HORSESHOE LAKE 2ND ADDITION

Re: S/D 98-4 -- Final Plat of HORSESHOE LAKE 2ND ADDITION

Re: S/D 98-4 -- Final Plat of HORSESHOE LAKE 2ND ADDITION

CASE NUMBER: S/D 98-4 - HORSESHOE LAKE 2ND ADDITION

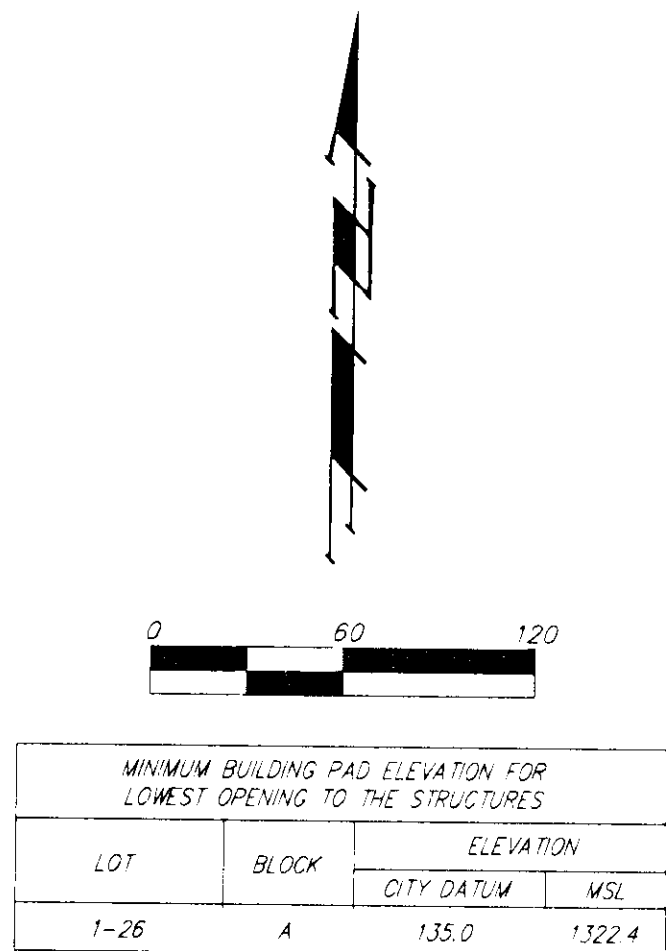
- A. City Engineering needs to indicate if guarantees are required for sanitary sewer or City water to serve this site. City Engineering has requested that easements be increased to 25 feet when shared by sanitary sewer, storm sewer and other utilities.

- C. City Engineering needs to comment on the status of the applicant's drainage plan. The drainage plan is approved. Wherever storm sewer, sanitary sewer and other utilities share an easement, it is requested that the width of the easement be increased to 25 feet.

- F. Since this plat proposes the platting of narrow street right-of-way with adjacent "15-foot drainage and utility easements", a restrictive covenant shall be submitted which calls out restrictions for lot owner use of these easements. Retaining walls and change of grade shall be prohibited within these easements as well as fences, earth berms and mass plantings.

- I. Traffic Engineering needs to comment on the need for any improvements to perimeter streets. Traffic Engineering has requested the elimination of the turnaround at the end of the existing street for safety reasons. Applicant desires to maintain the cul-de-sac to provide a separation between the commercial and residential uses.

- The Subdivision Committee required the following: a) the existing turnaround be maintained, b) a 15-mph sign be posted 200-ft south of the existing cul-de-sac, c) A stop sign be posted at the existing cul-de-sac, d) A No Outlet sign be posted on 21st St., and e) A No Parking sign be posted within the existing cul-de-sac.

- J. Fire Department needs to comment on the acceptability of the cul-de-sac access. Lakeway Court (approx. 650 feet) exceeds the maximum length of 600 feet as specified in the Subdivision regulations. The street length is acceptable due to topographical constraints.

- L, Fire Department needs to comment on the acceptability of the street names. The names of Lakeway Court and Lakeway Circle should be transposed. The final plat has denoted said revision.

- S. The representatives from the utility companies should be prepared to comment on the need for any additional utility easements to be platted on this property. The representatives from Southwestern Bell and KGE have requested additional easements. The easements have been denoted on the final plat.

- U. "Section 24" should be corrected to read "section 3" in the surveyor's certification.
- V. Unified maintenance of the adjoining lake in Reserve F of the Horseshoe Lake Addition should occur; consisting of homeowners in both Additions.

- X. On the final plat tracing, a note shall be placed on the face of the plat indicating that this Addition is subject to the conditions of Community Unit Plan DP-75 Amendment #1.

At the regular meeting of the MAPC on March 12, 1998, the above-captioned plat was considered. The action of the Planning Commission was to recommend that the plat be approved as recommended by the Subdivision Committee subject to conditions stated in our letter of March 6, 1998, with the exception of Item I. Item I shall be replaced with the following:

- A. The existing turnaround at the end of the existing street be retained,
- B. ~~A stop sign be posted north of the existing cul-de-sac for southbound~~
~~traffic,~~
- C. A No Outlet sign be posted on Lakeway Circle, and
- D. No Parking Signs shall be posted within the existing cul-de-sac.
